ARCHITECT'S SUPPLEMENTAL INSTRUCTIONS

PROJECT:	The Reserves at Magnolia New Apartment Complex Denton, TX	Report No.	One (1)
OWNER:	Overland Property Group Dan Maximuk 234 N. Santa Fe Ave, Suite A Salina, KS 67401	Date	Oct. 22, 2024
CONTRACTOR:	Snyder Construction Group 4820 N. Town Centre Dr. Ozark, MO 65721	Architect's Proj No.	21-3205
		Contract For:	General Construction Mechanical, Electrical

Please Note: Drawings and Specification Edits associated with this ASI are dated as **7-17-2024**. This date above is the date this ASI was issued.

A3.1

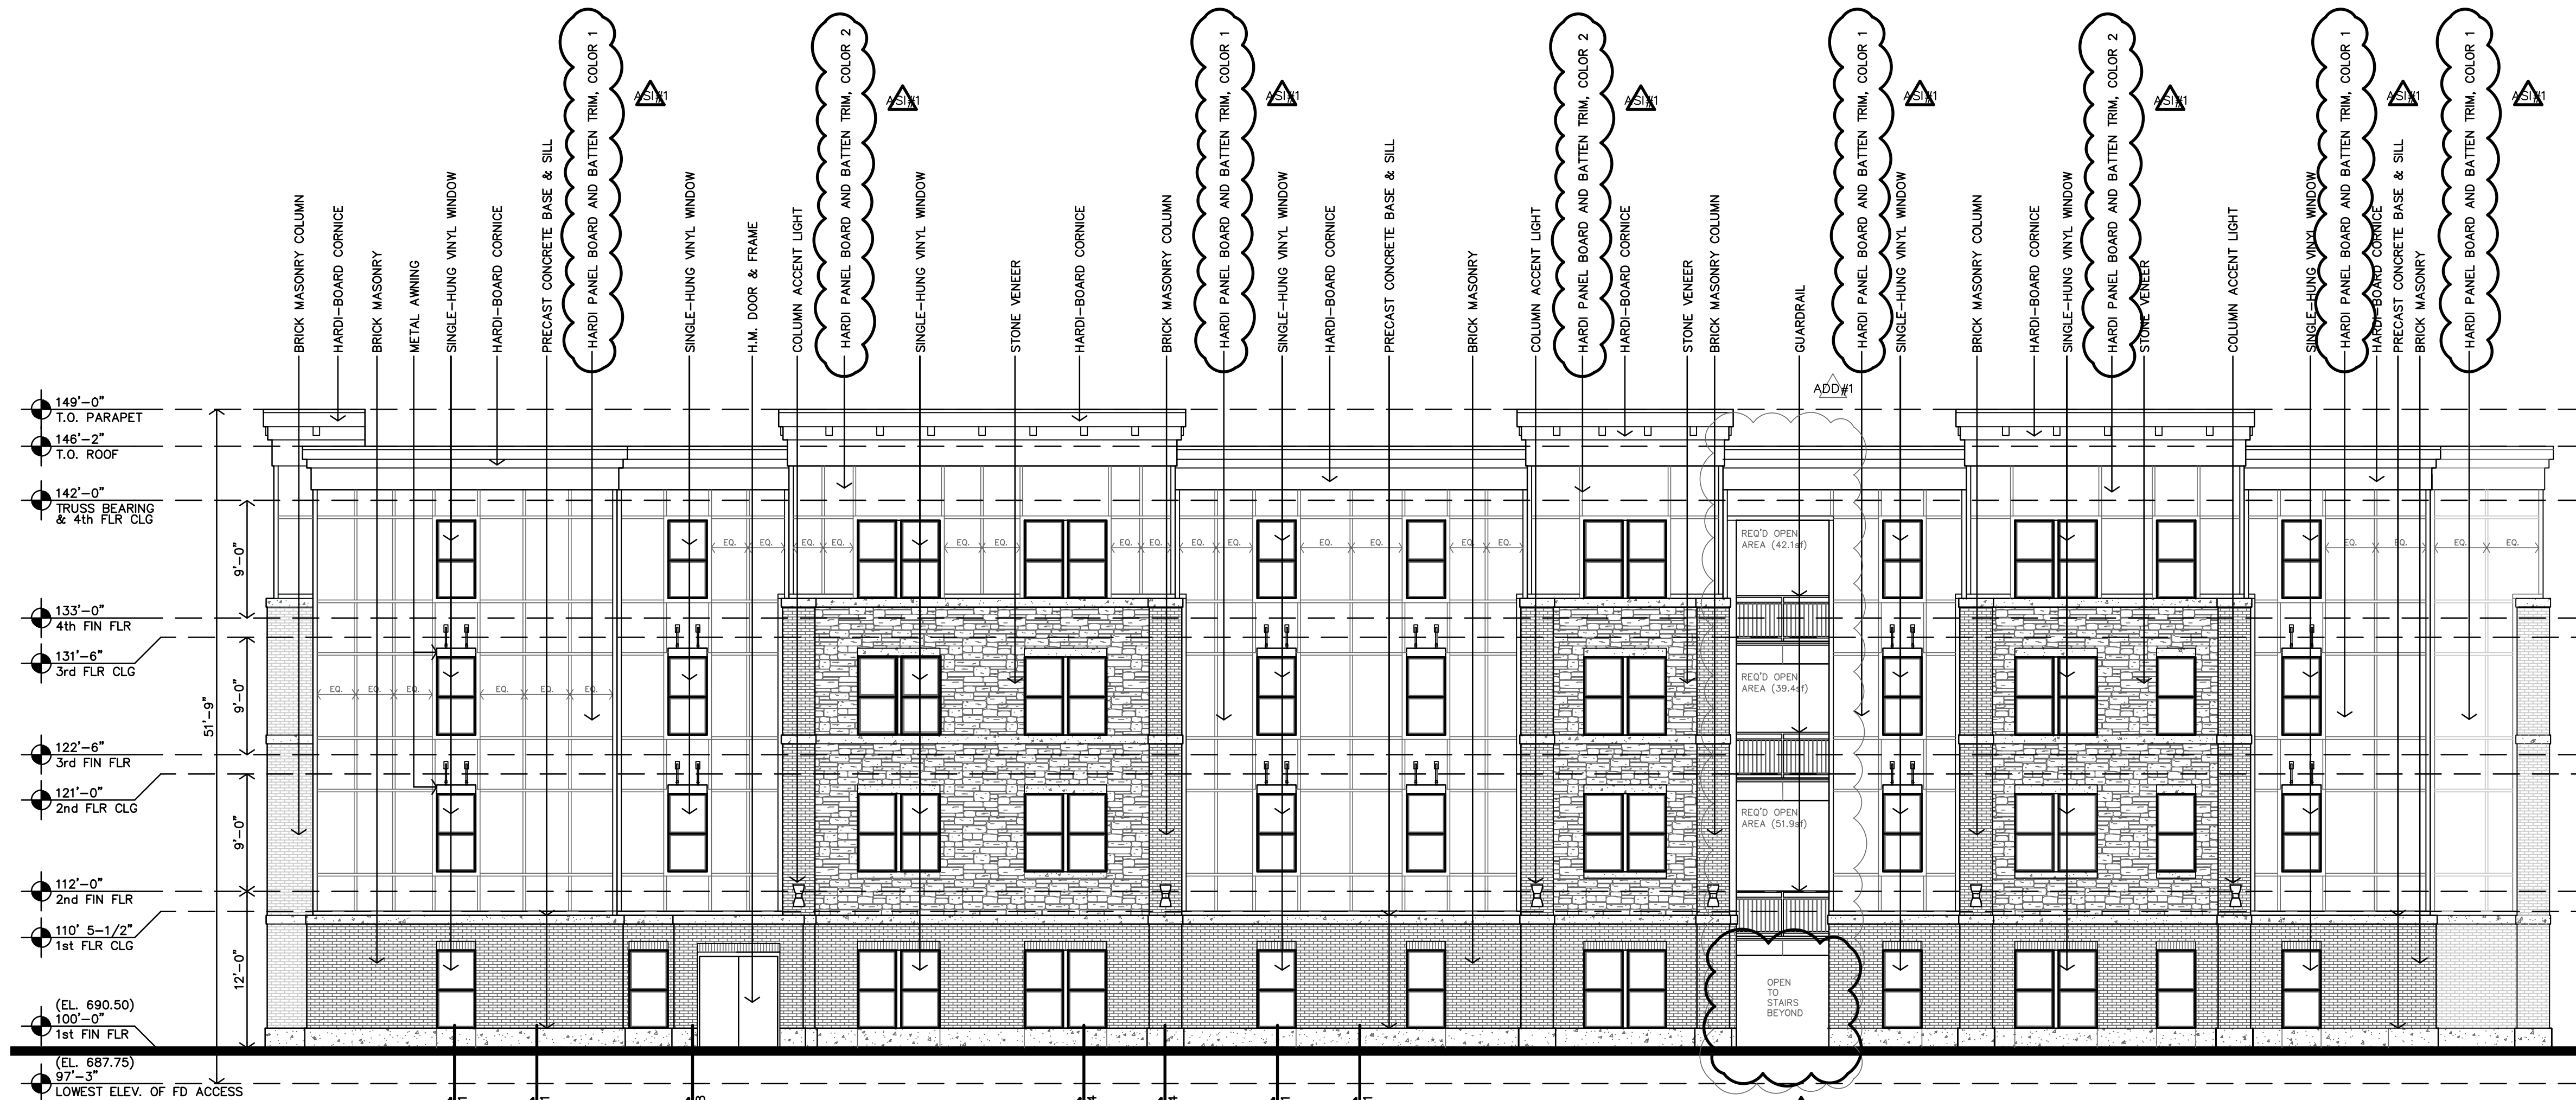
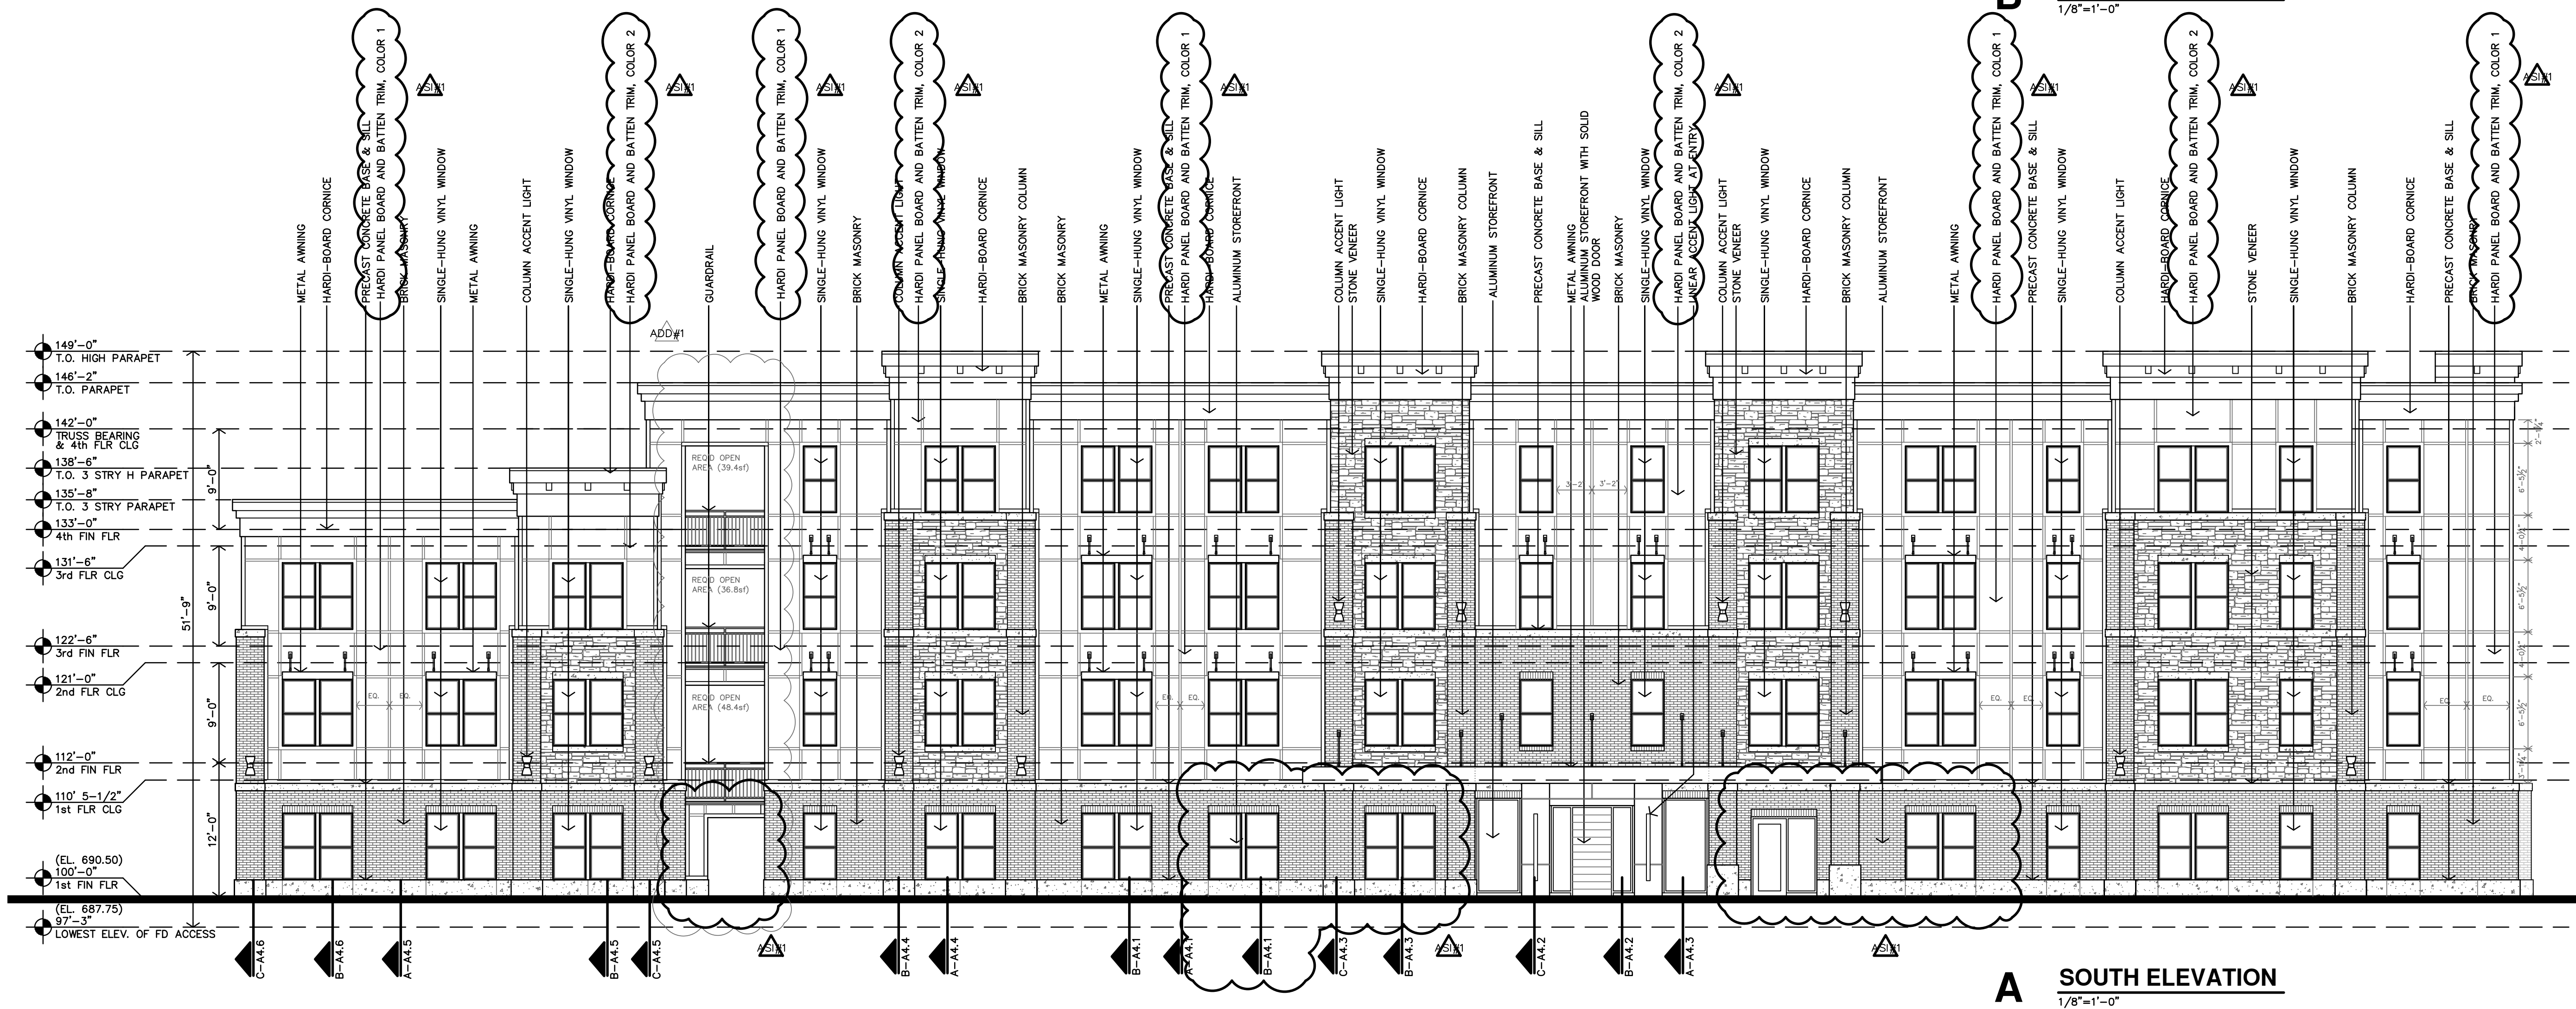
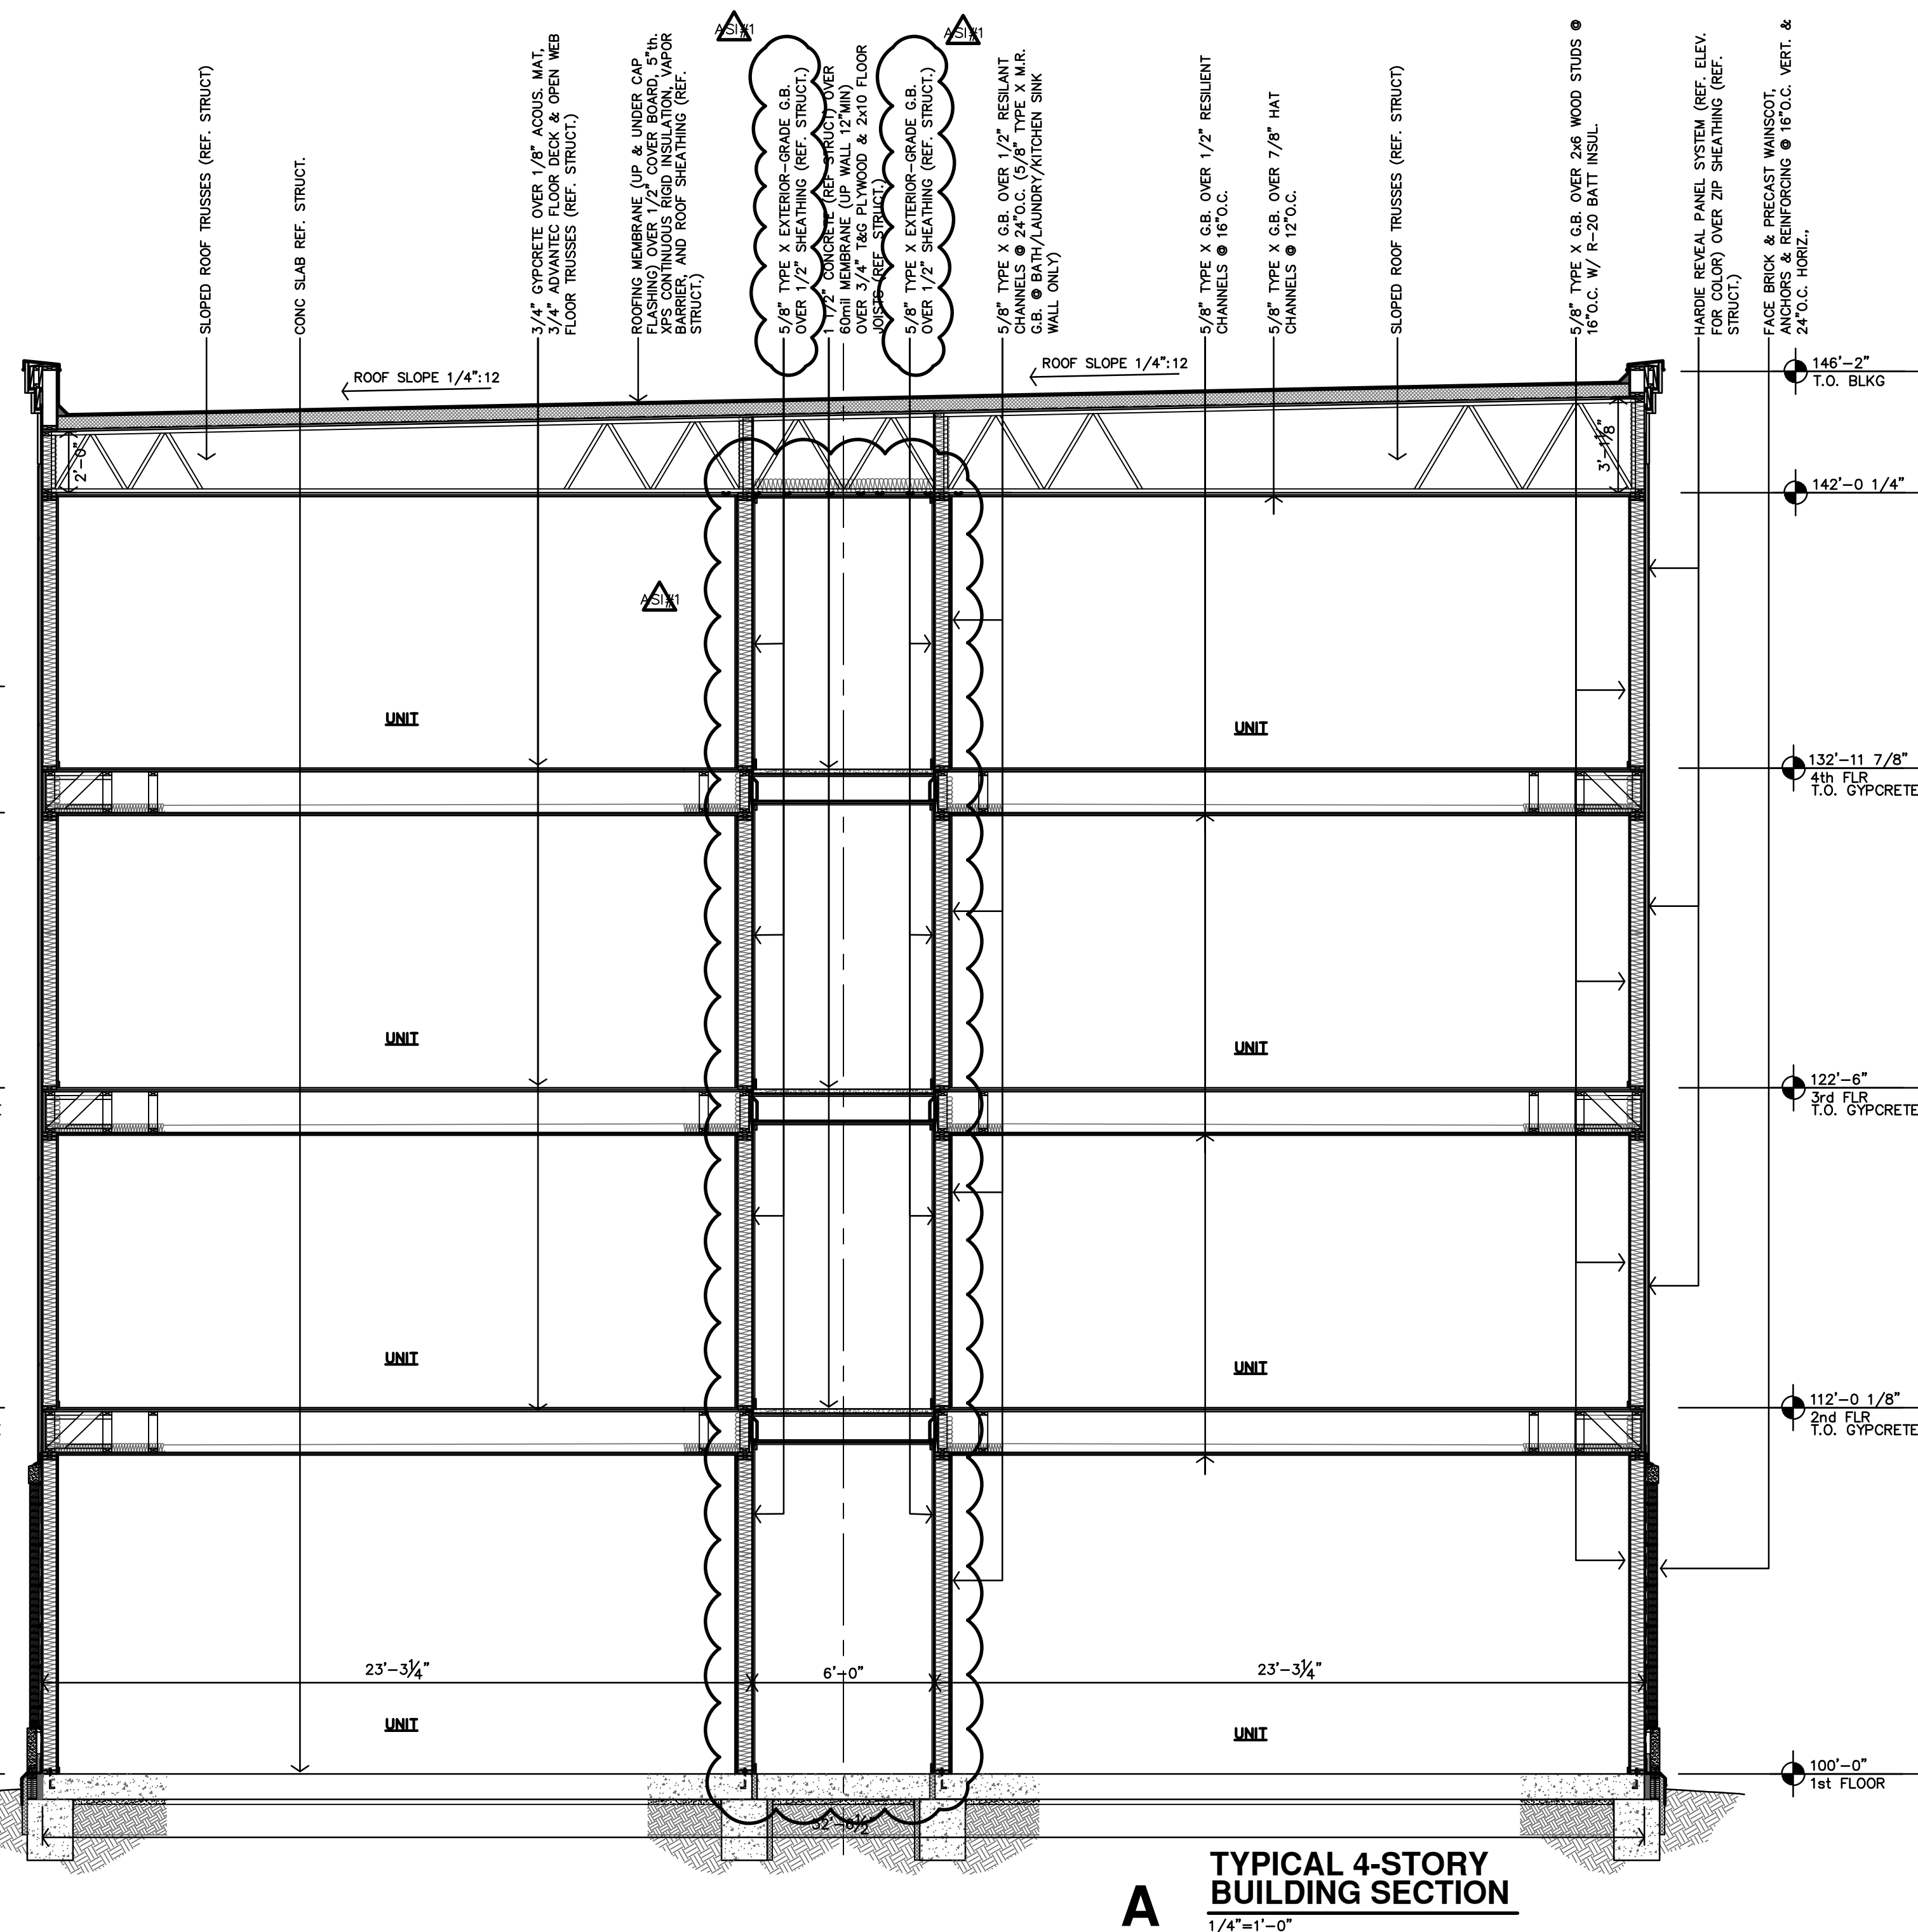
- 16) Utilize hardie board and batten (smooth finish) in lieu of hardie reveal panels on the exterior façade. Reference revised elevations on A3.1 and A3.2 (VE Item #20)

- 17) Omit Security Gate and Doors #114, #116, #121 and #122. (VE item #22). Reference revised plans and details on Sheets A2.1, A3.1, A3.2, A6.1, A6.2 and A10.2.

- 38) Reduction in Storefront (VE Item #44) Reference revised Sheets A2.1, A3.1 and A10.2
 - a. Omit Storefront Windows C & D, replace all with Window A.
